# 2100 Queen Anne Avenue N

SDCI# 3034141-LU  
DESIGN RECOMMENDATION MEETING  
12/2/2020

DEPARTURE REQUEST #6 - GROCER ENTRY MORE THAN 10' FROM PROPERTY LINE

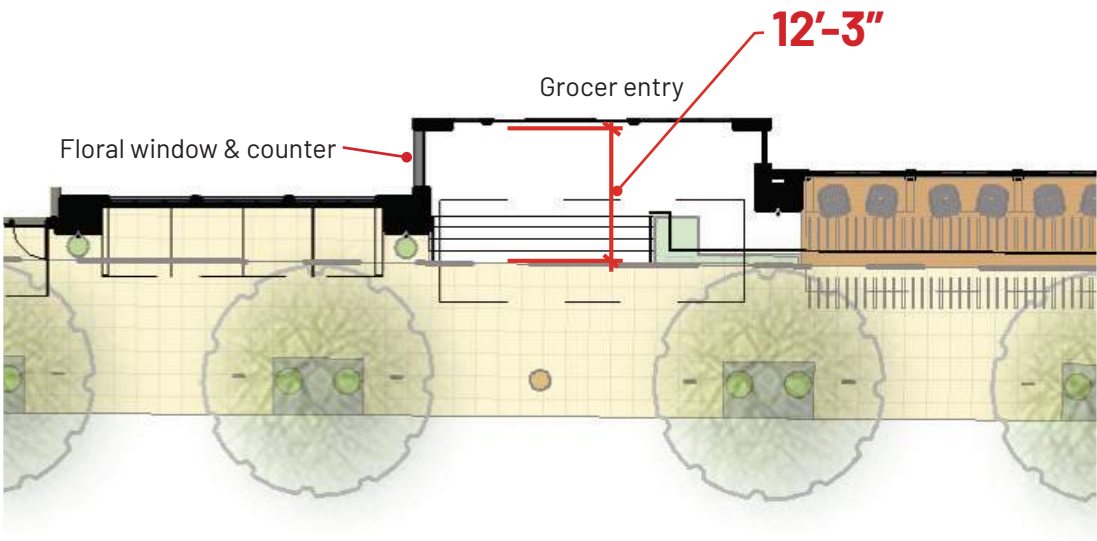
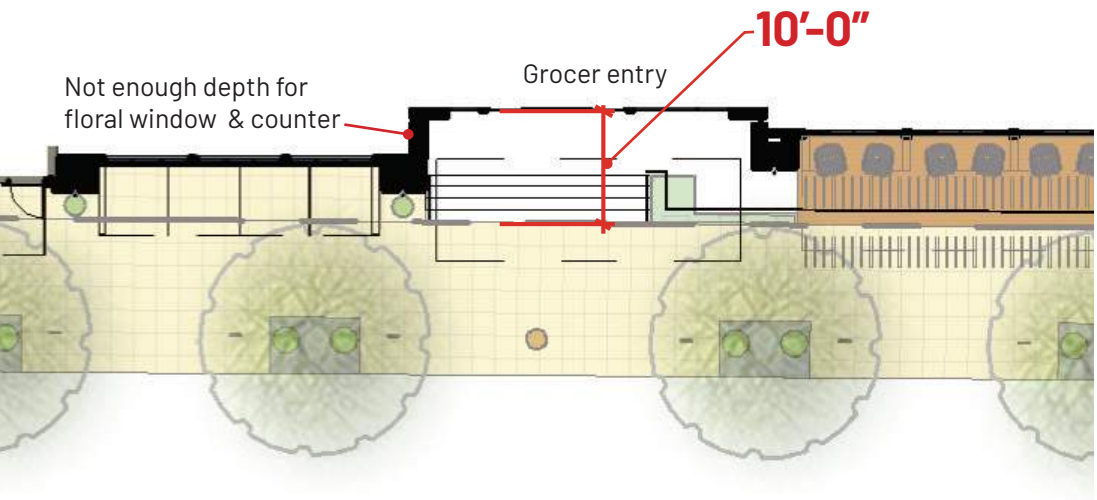
23.47A.008A.3 - Street Level Requirements: Street-level street-facing facades shall be located within 10 feet of the street lot line, unless wider sidewalks, plazas, or other approved landscaped or open spaces are provided.

The additional depth of the grocer entry allows for the floral order window to be located at the exterior facade. The window is a reference to the old Queen Anne Met Market floral window and will provide a richer pedestrian experience along Queen Anne Ave N and additional pedestrian interactions. This reinforces the Queen Anne Design Guideline CS3 Architectural Context & Character -Streetscape Compatibility that requires buildings to reflect a diversity of architectural shapes, sizes, styles themes, wider sidewalks, and streetscape improvements to enhance the pedestrian experience.

DEPARTURE REQUEST #7 - CANOPIES ALONG QUEEN ANNE AVE ARE NOT CONTINUOUS

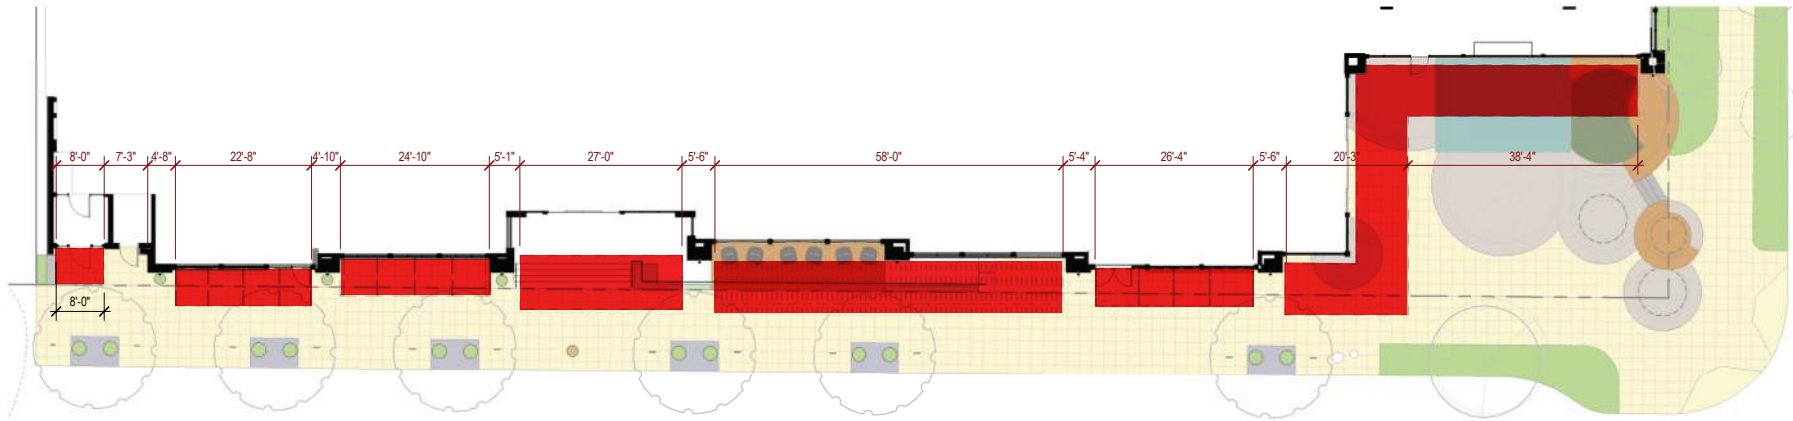
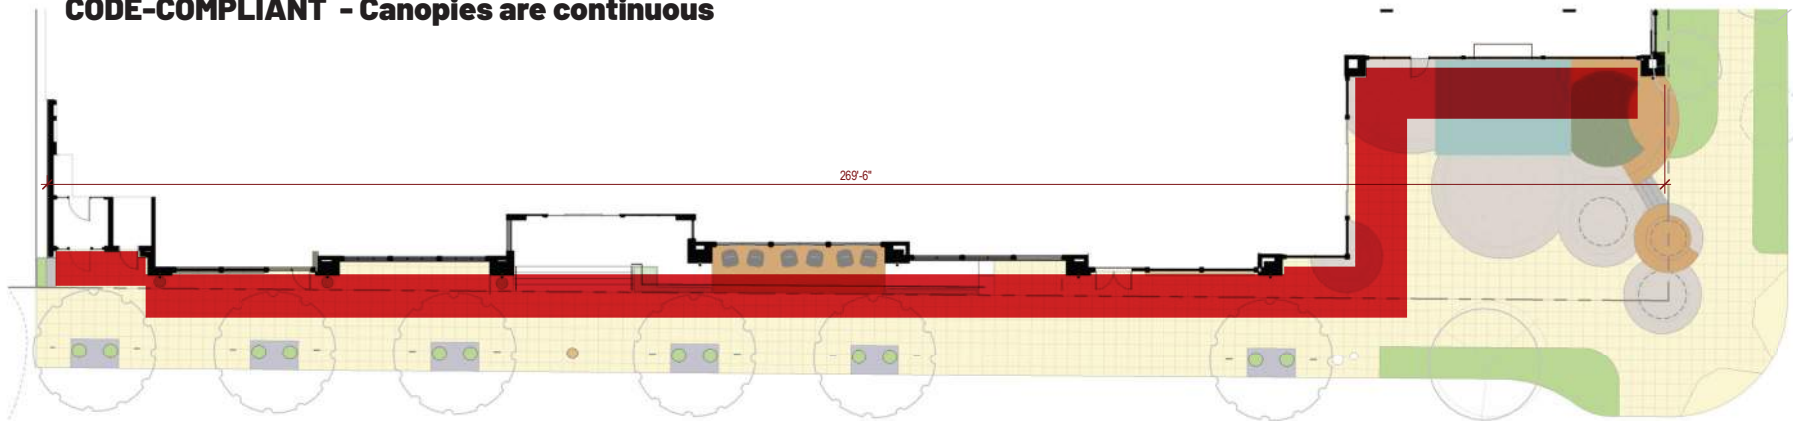
Request to allow for continuous overhead weather protection to be broken up at each brick pier.

Proposed design includes a variety of canopy sizes and shapes that occur between each brick pier. This is characteristic of the Queen Anne retail context and responds to the following Queen Anne Neighborhood Design Guidelines:
